BALTHROP THIRD ADDITION

RE: S/D 99-50 -- One-Step Final Plat of BALTHROP 3RD ADDITION

RE: S/D 99-50 -- One-Step Final Plat of BALTHROP 3RD ADDITION

CASE NUMBER: S/D 99-50 - BALTHROP 3RD ADDITION

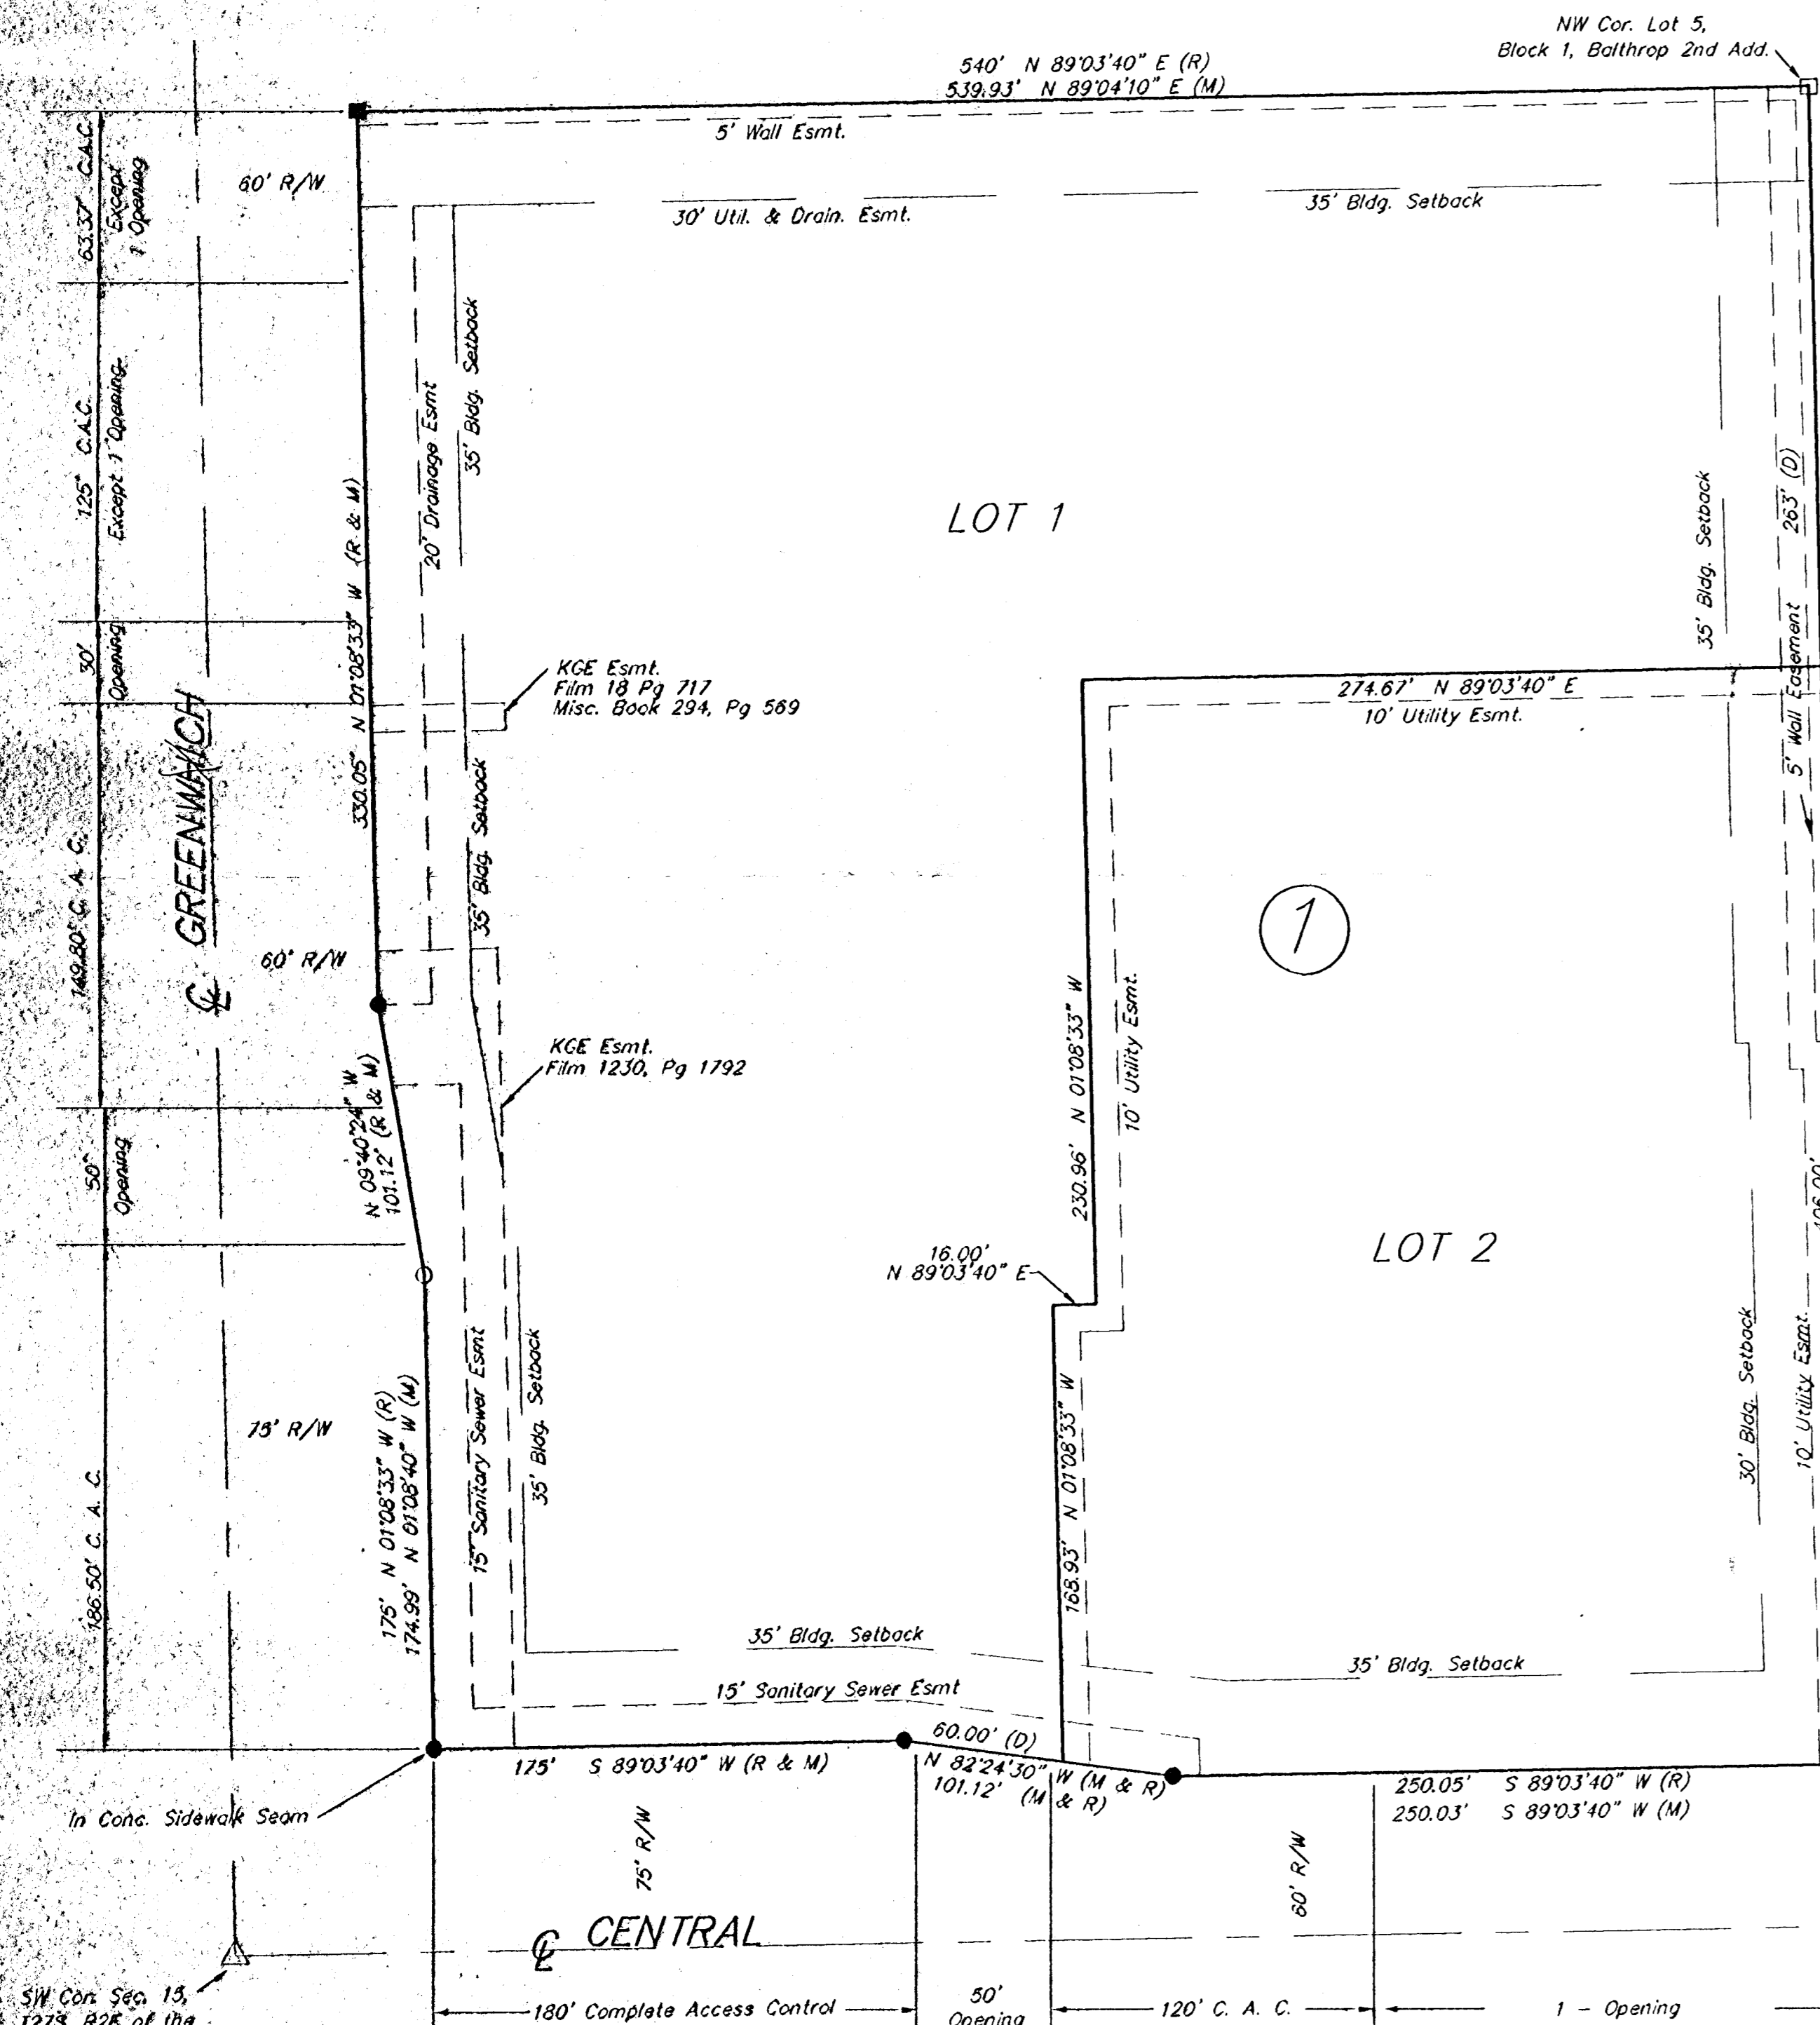
- A. This site is located in the County's Four Mile Creek sewer system and is served by the County. *A new sewer petition is required along with a sanitary sewer layout.*

- B. *City Engineering* need to comment on the existing guarantees and the need for providing new or revised guarantees. *A guarantee for extension of stormwater sewer is required. A cross-lot drainage agreement and off-site drainage agreement are required.*

- D. *City Engineering* needs to comment on the status of the applicant's drainage plan. *A drainage plan has been approved.*
- E. *Traffic Engineering* shall comment on the access controls. *Two openings along Central and two openings along Greenwich are permitted for this plat. 125 feet of complete access control is required from the north line of the plat. The westernmost opening along Central is limited to right turns only.*

- H. An adjustment to the CUP will be needed for any revisions in the access controls.
- I. On the final plat tracing, a note shall be placed on the face of the plat indicating that this Addition is subject to the conditions of Community Unit Plan DP-232.

- R. The representatives from the utility companies should be prepared to comment on the need for any additional utility easements to be platted on this property. *Southwestern Bell has requested additional easements.*
